**From:** Jennifer Sanchez [mailto:jsanchez@metlabs.com]  
**Sent:** 2008年8月2日 8:05  
**To:** Xu, Anya (Shanghai); Cai, Cai (Shanghai)  
**Cc:** Shawn McMillen; Len Knight; Chris Harvey; Angela Kekovski; Jenn Warnell; Jennifer Sanchez  
**Subject:** 81012 SGS - Request for Additional Information  
**Importance:** High

**From:** Jenn Warnell [mailto:jwarnell@metlabs.com]  
**Sent:** 2008年7月8日 1:04  
**To:** Xu, Anya (Shanghai)  
**Cc:** Jenn Warnell; Jennifer Sanchez; Angela Kekovski; Chris Harvey  
**Subject:** EMC81012 - FCC for Part 22/24

**From:** Chris Harvey [mailto:charveyemc@gmail.com] **On Behalf Of** Chris Harvey  
**Sent:** 2008年7月30日 21:32  
**To:** Xu, Anya (Shanghai); 'Jenn Warnell'  
**Cc:** 'Jennifer Sanchez'; 'Angela Kekovski'  
**Subject:** Additional information needed for METrak# 81012 : FCC ID: RAD078 TCB Application - Notice #2

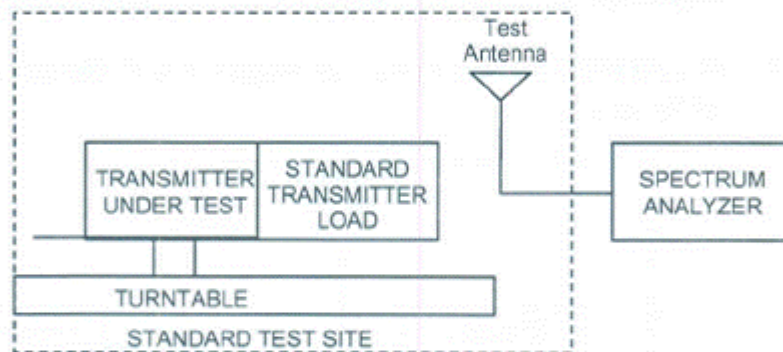
The original test report indicated that a 100kHz RBW was used for the ERP measurements. The updated test report states that the Spectrum Analyzer was set to 250kHz, but the measurement values are identical to the measurements using 100kHz. The ERP measurements should be performed with a 1MHz RBW.

Please confirm the measurement instrument (Spectrum Analyzer) settings for the ERP power measurements on page 17 for below 1GHz. According to the remarks, the RBW was set to 100kHz, which is smaller than the emission bandwidth of approximately 250kHz.

The test procured is TIA/EIA 603C for license bands transmitter. I can not find the spectrum setting for fundamental ERP/EIRP testing, but I got Unwanted emission setting as below. It could be a reference.

For GSM 850 Band ERP testing, due to the emission bandwidth is around 250KHz, so I believe RBW 250KHz, and VBW1MHz is enough to cover bandwidth 250KHz, I don't think it requires 1MHz RBW.

For GSM 1900 Band EIRP testing, emission bandwidth is around 250KHz also, but it's above 1GHz, so we used RBW 1MHz, and VBW 3MHz.
